# Access Compliance Report

## Public Rights-of-Way

### (Curb Ramps)

Intersection ID: 12048	Main Street: S_GRAHAM_ST	Cross Street: W_3RD_ST	Location:	N
ADA ID: 3C193886FD62	Ramp Type: Directional1	Initial Pass/Fail: Fail	Overall Compliance: No	Severity Score: 12.5
Codes/Mitigation Info/Possible Solution		Field Measurements/Component Compliance

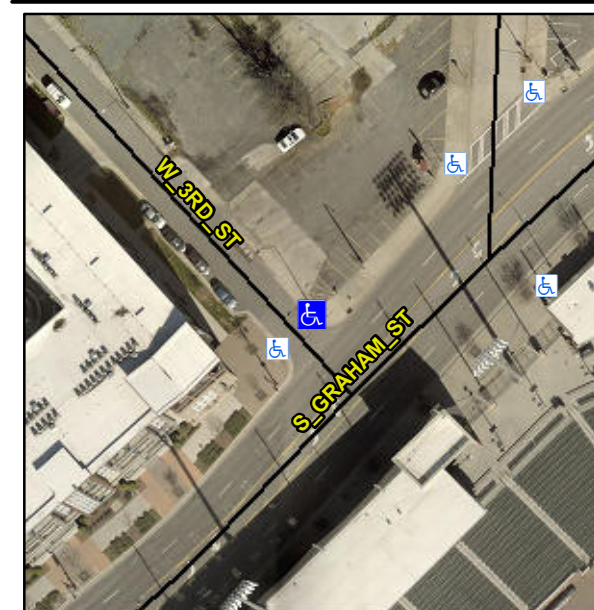
**R304.2.2**

**Remove & Replace Entire Ramp.**
